City of West Linn
PRE-APPLICATION CONFERENCE MEETING
Notes
June 3, 2010

SUBJECT: Installation of roof above patio attached to house at 18444 Nixon Avenue, in Flood Management Area

Project #: PA-10-16

**SITE
PLAN**

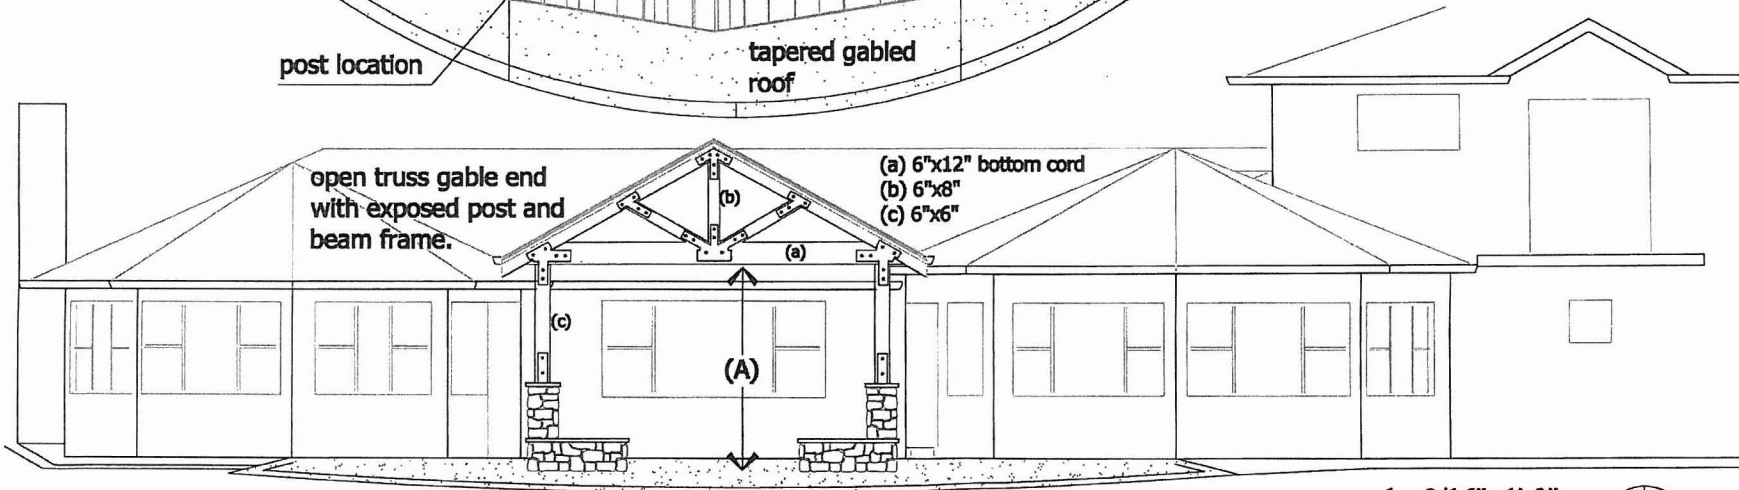
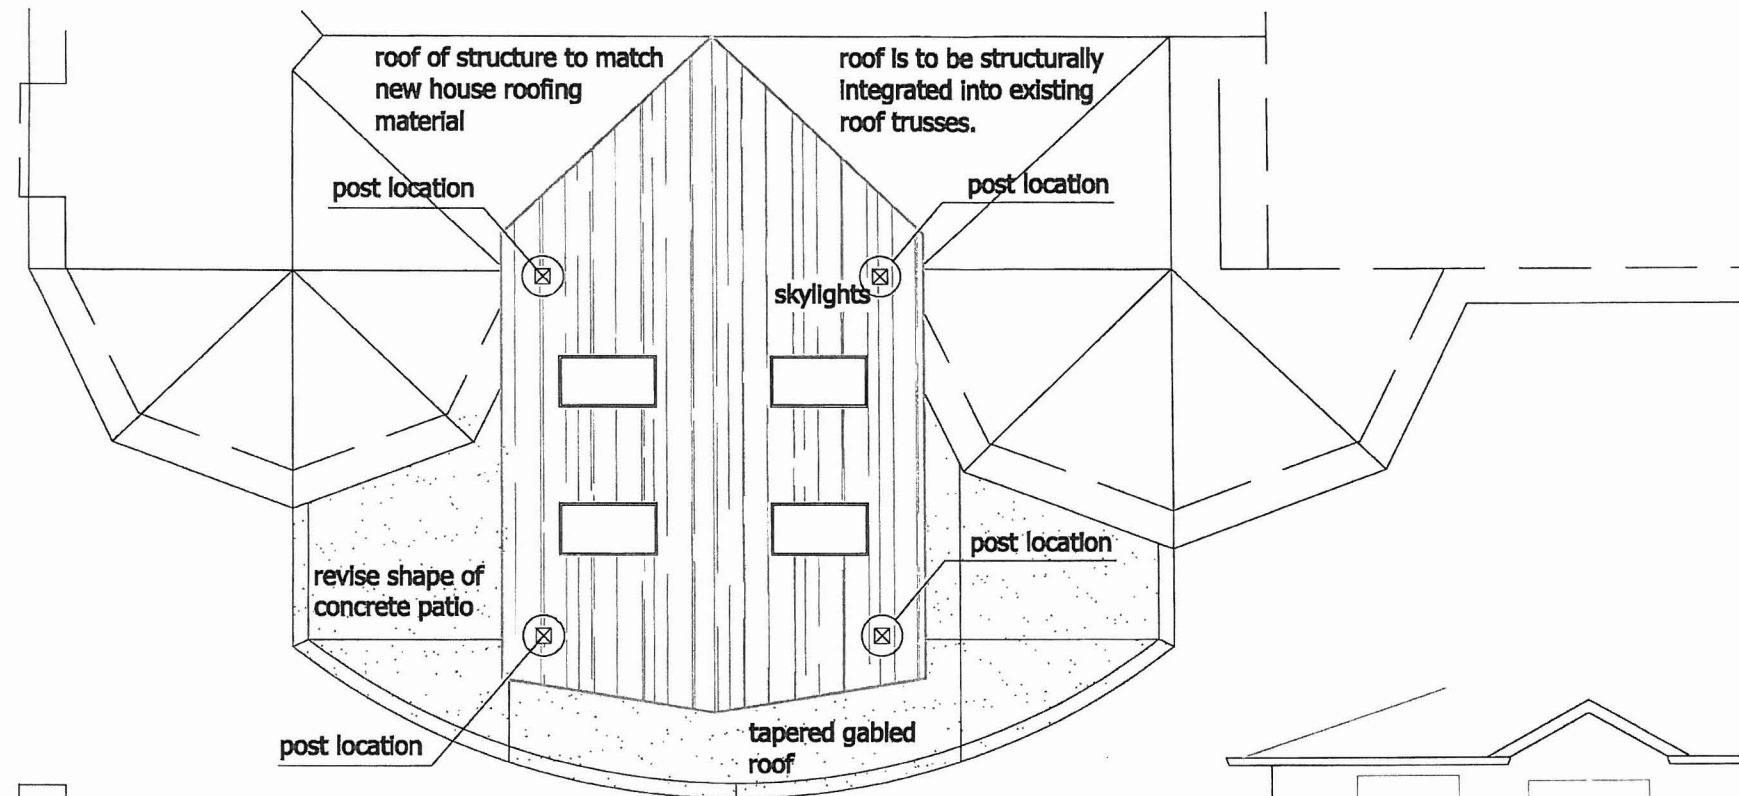
The part of the property where development is proposed is within the transition area of the wetland downhill by the river as well. The site plan submitted for the pre-application conference indicated that the patio would be expanded to the north and south. If the patio is extended more than 10 feet laterally or towards the bank at all, this would require a Water Resources Area permit (which would likely not be approved as it is not necessary development in the transition area). However the applicant's representative confirmed verbally at the pre-application conference that patio expansion is no longer part of the applicant's plans. Revisions to the existing patio, and building the cover over existing parts of the patio, are both exempt from the Water Resource Area permit because these involve no further encroachment into the transition area.
